# service information

No. 99-12

## 3.0 Litre Mounting Height

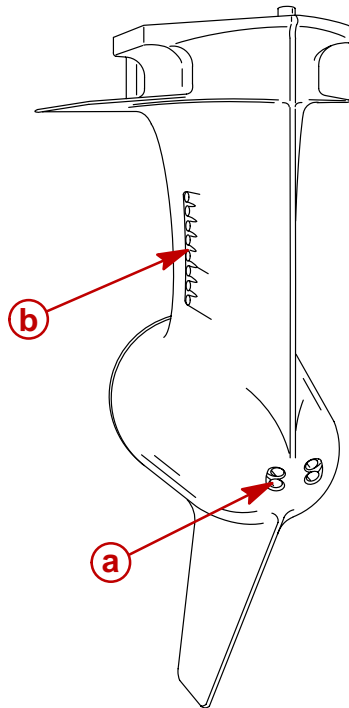
The 2000 model year 3.0 Litre product will have a new lower unit with dual water inlets. This new gear case will have water inlets on the front/leading end of the torpedo, in addition to the standard side water inlets. The new design will allow for better water flow to the engine when used on stepped bottom boats, which generally create a high amount of air-ventilated water.

- a** - Front water inlets
- b** - Side water inlets

The change in gear case design does **NOT** change the mounting height requirements for the engine. Mounting the engine above the recommended height could cause the engine to overheat, damage to the propeller shaft and bearing carrier, and premature product failure. Damage due to mounting heights above recommendations will **NOT** be covered under warranty. See engine installation manual for correct mounting height.
